STATE OF NORTH CAROLINA  
DEPARTMENT OF TRANSPORTATION

**Addendum No. 2**

RE: Contract # C205165

SITES 936-940, 942-944, 314, 316-321, 941: US-176 FROM 0.1 M N OF THOMPSON RD TO 0.8 M EAST OF BEAR CREEK LN. W03293

PROJECT REFERENCE NO. W03293	SHEET NO. 5
RW SHEET NO.	
ROADWAY DESIGN ENGINEER NORTH CAROLINA PROFESSIONAL SEAL 35018 JIMMY L. TERRY 7/10/2026	HYDRAULICS ENGINEER NORTH CAROLINA PROFESSIONAL SEAL 024897 John W. Wisdole, Jr. 7/10/2026

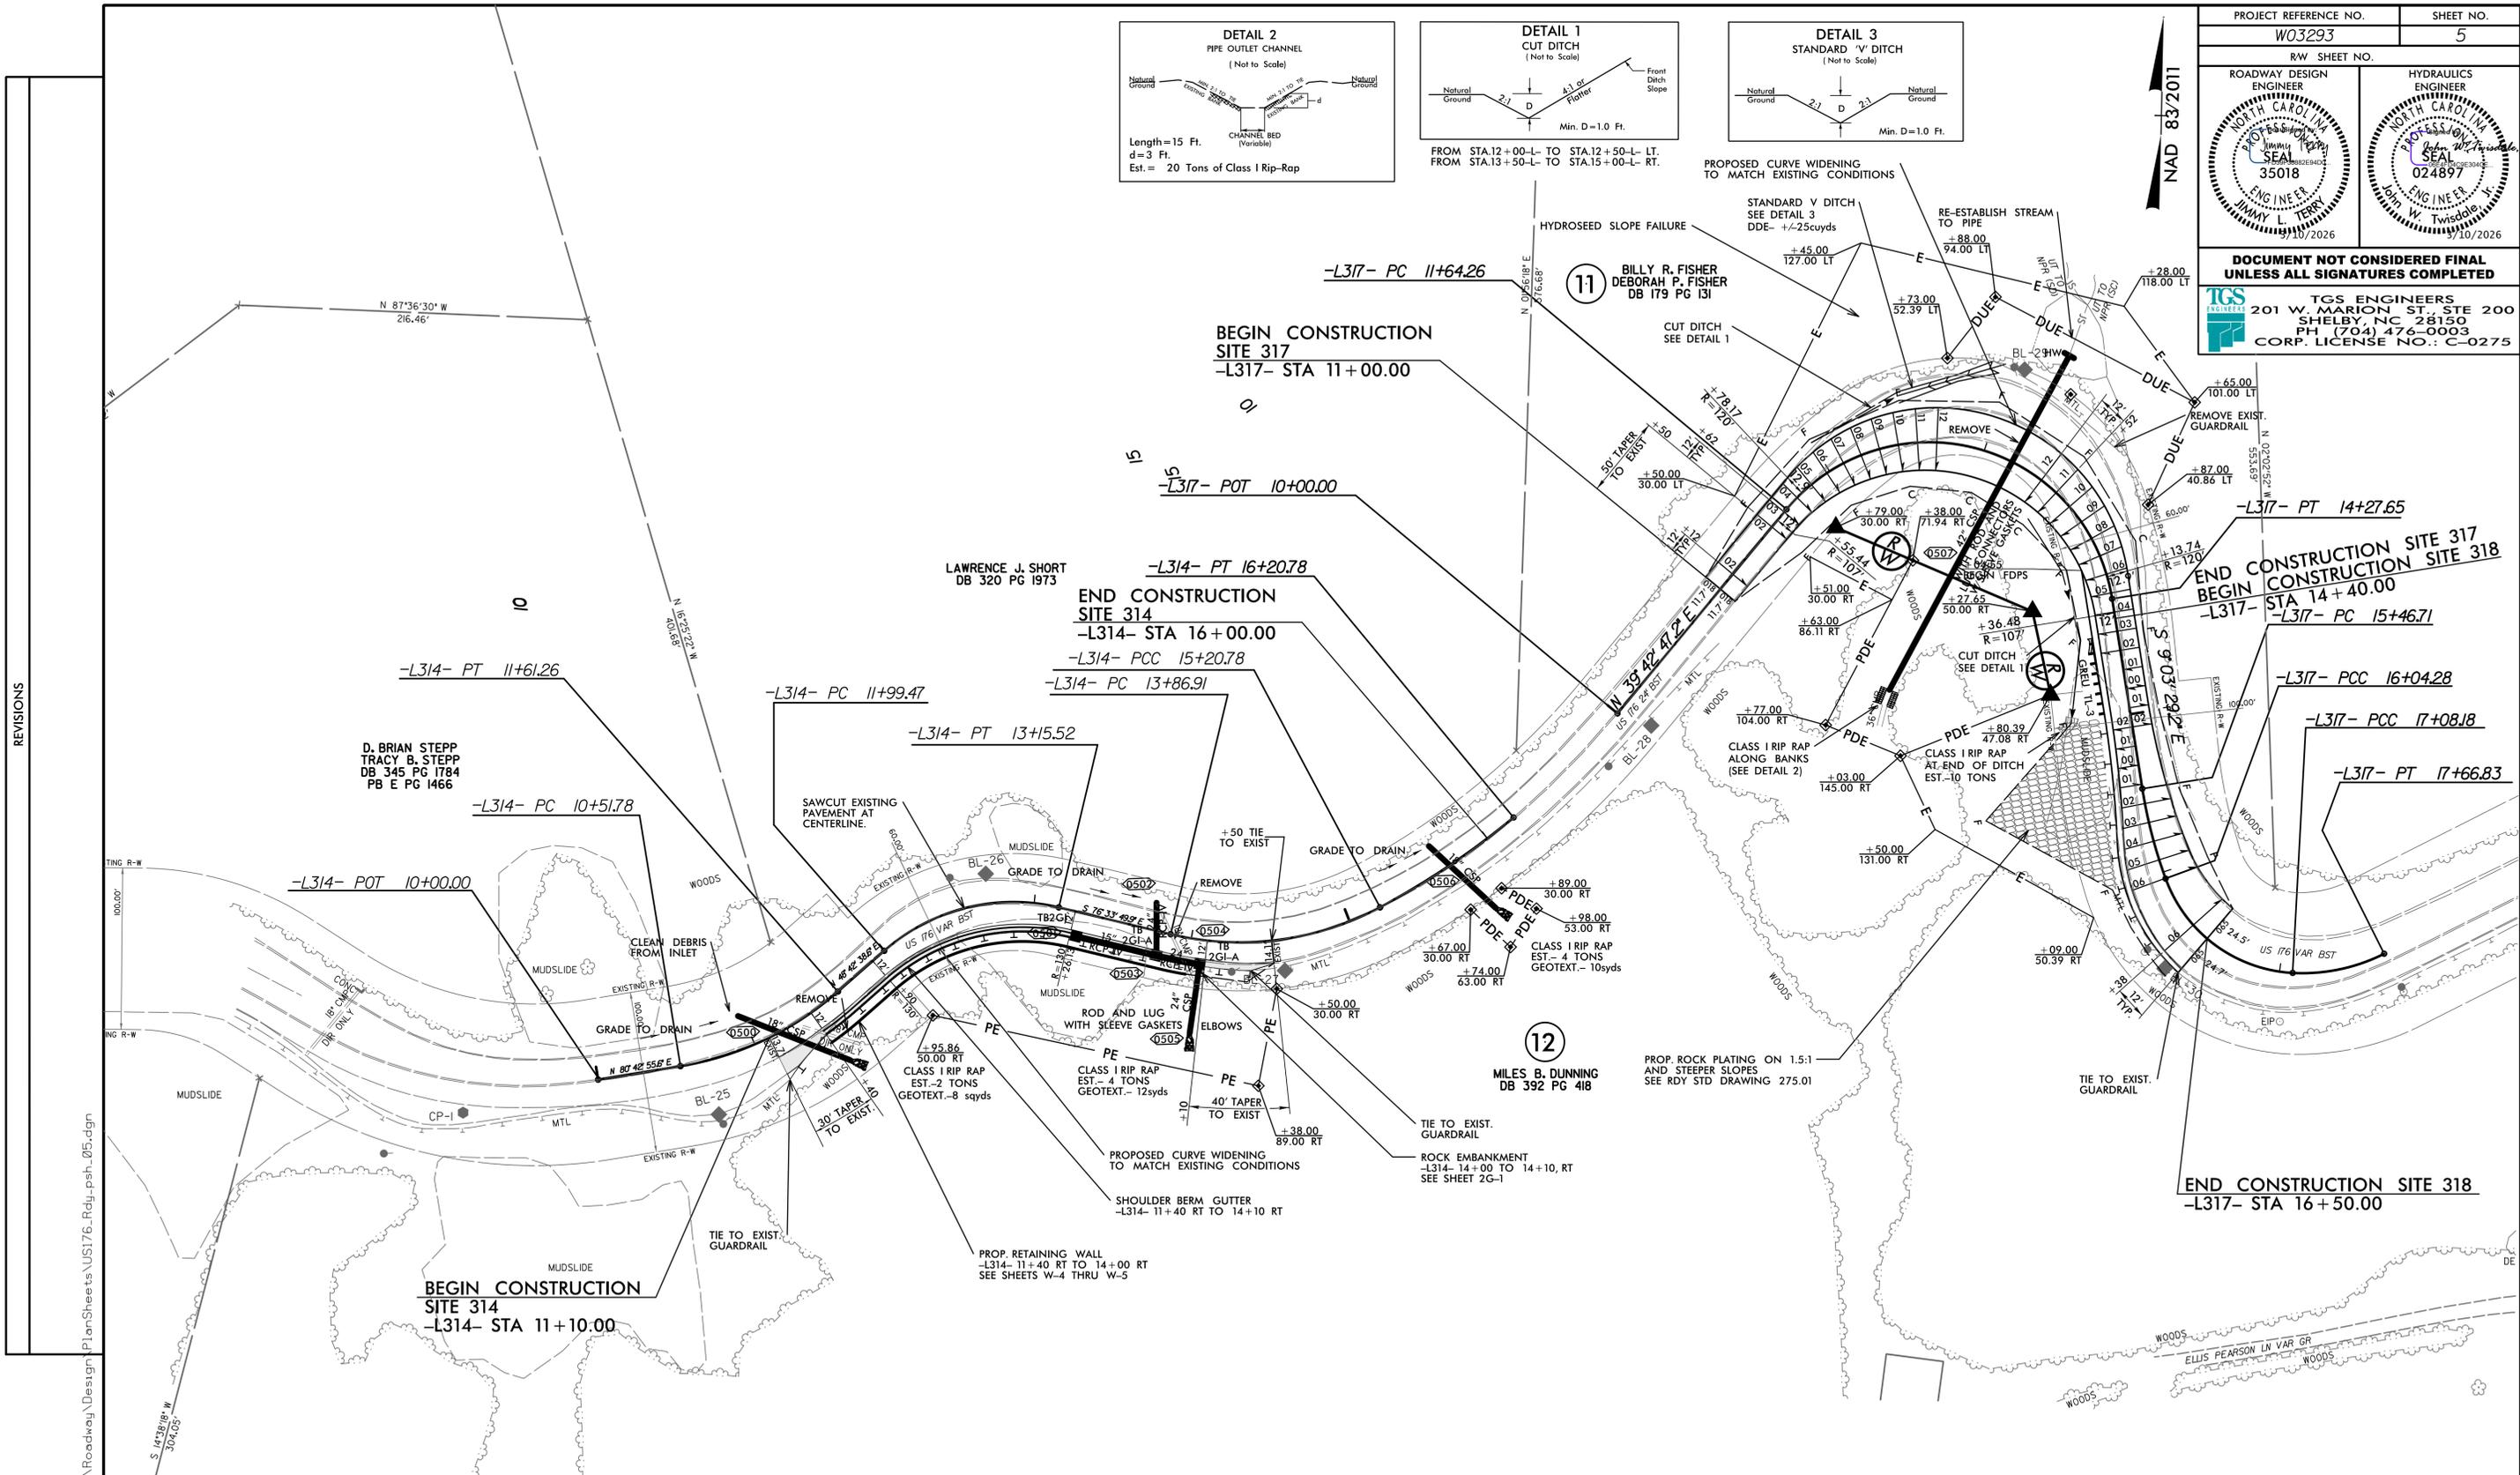
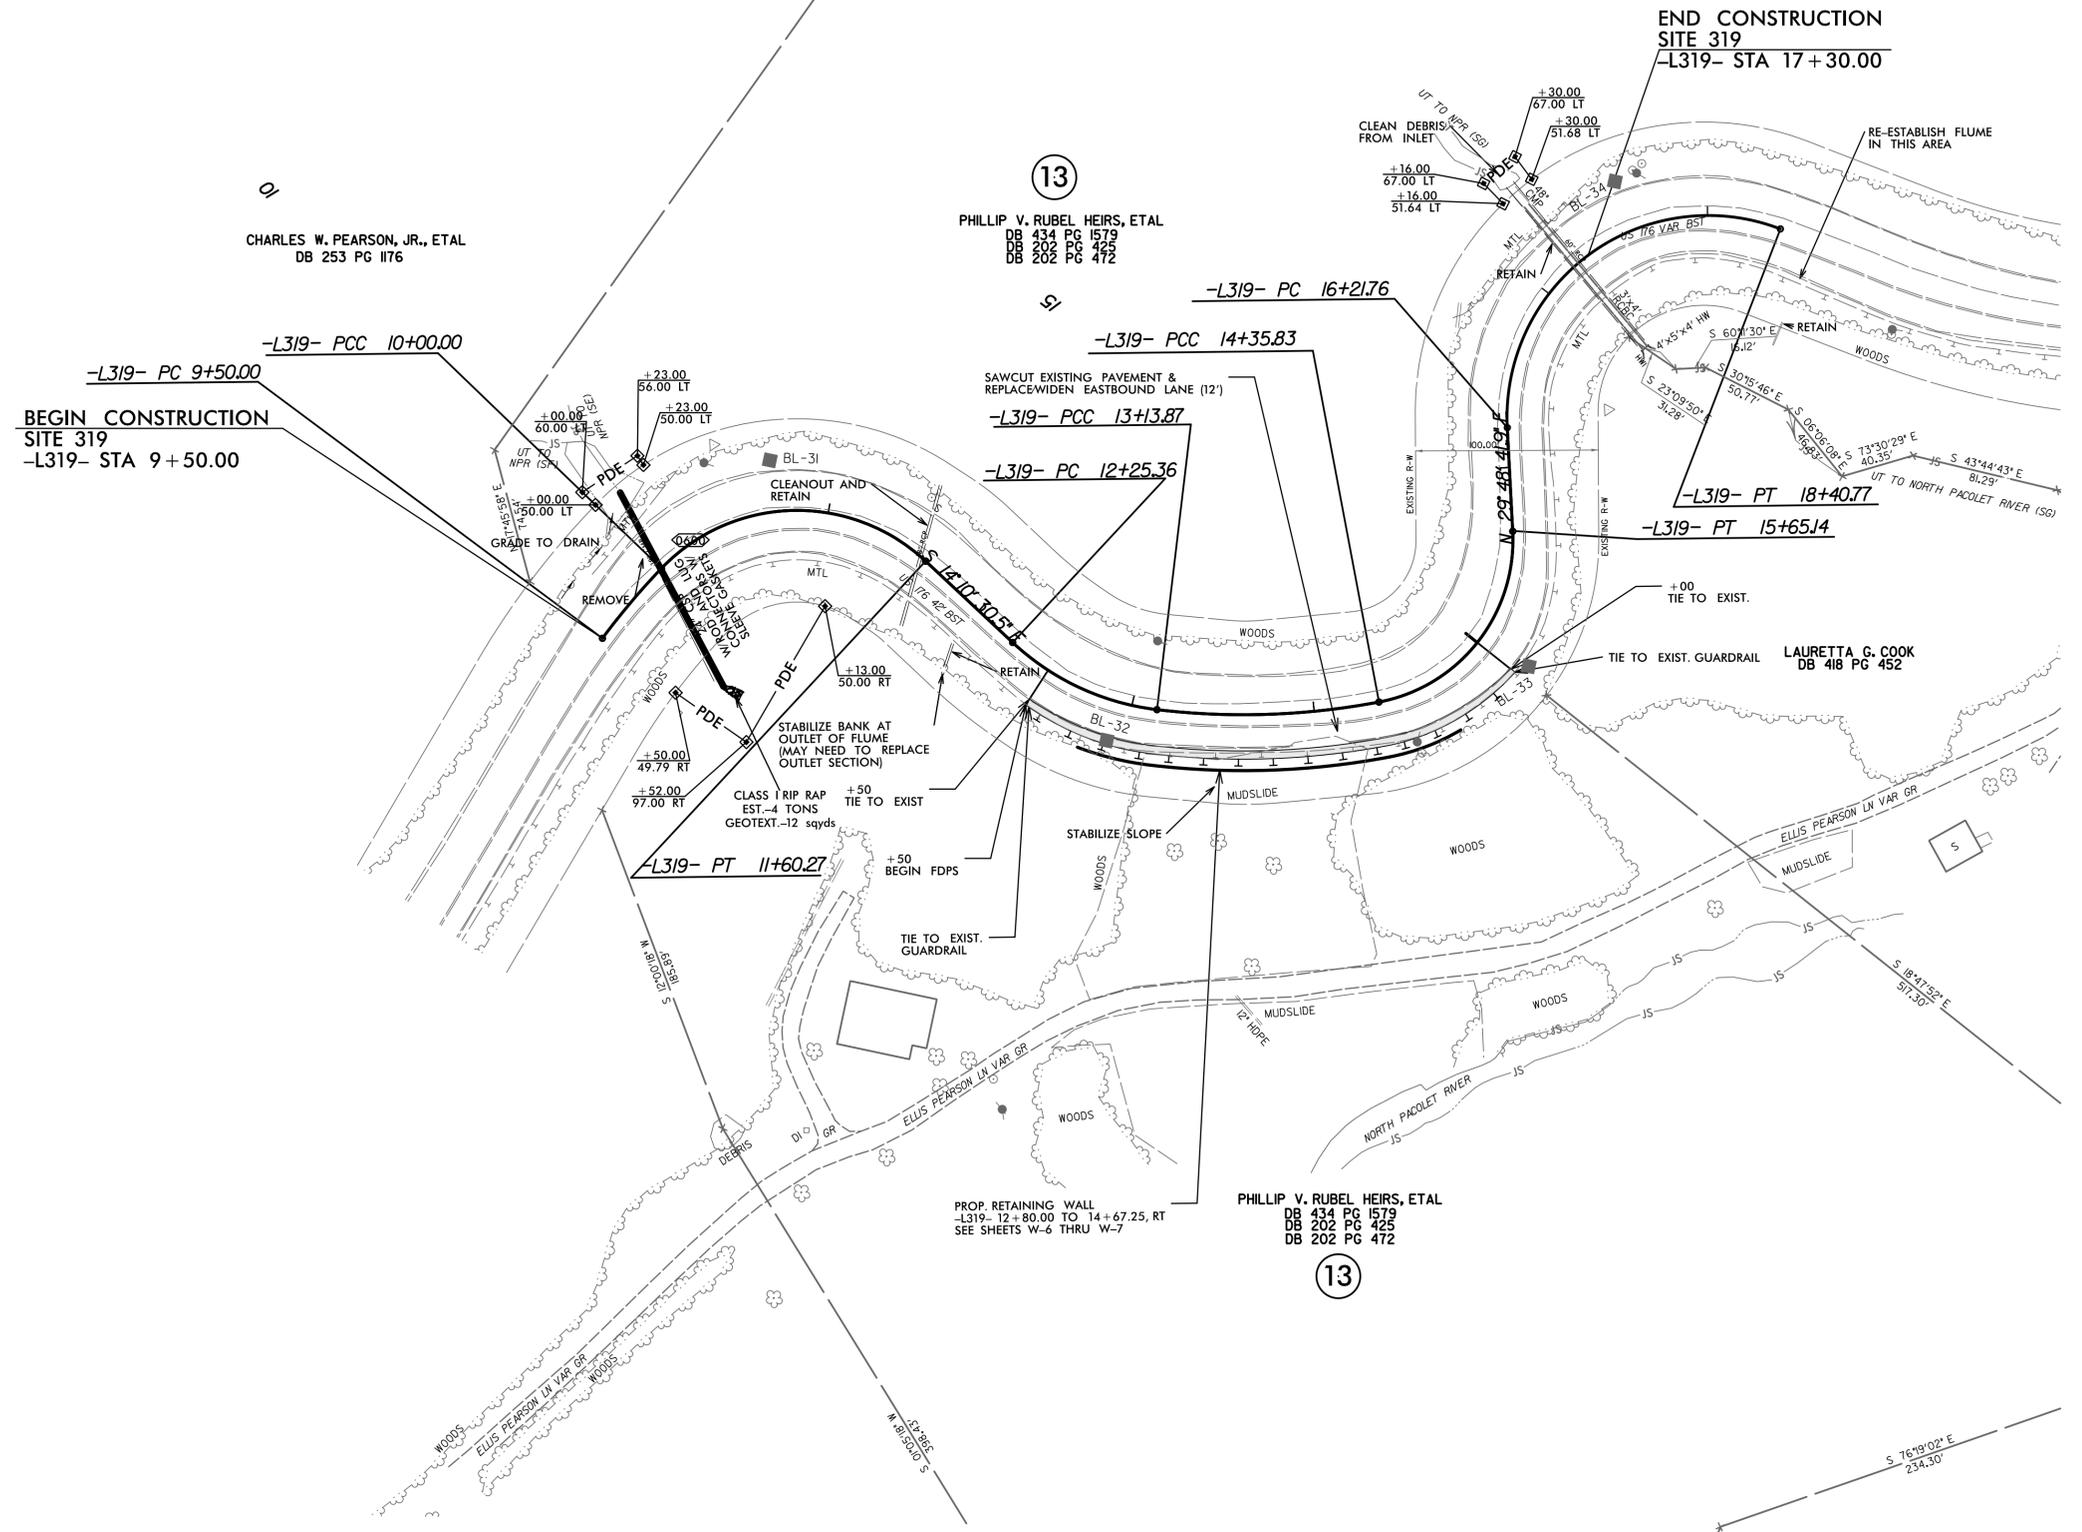
Sheet No.	Revision
3D-1 (Part 1)	Updated Totals and Combined Project Totals – Quantities shown below.
3D-2 (Part 1)	Revised label for “Combined Project W03293 Totals”.
6 (Part 1)	Revised note for DS-600.
3D-2 (Part 2)	Revised quantities – shown below.
12 (Part 2)	Revised – removed “grade to drain” note.
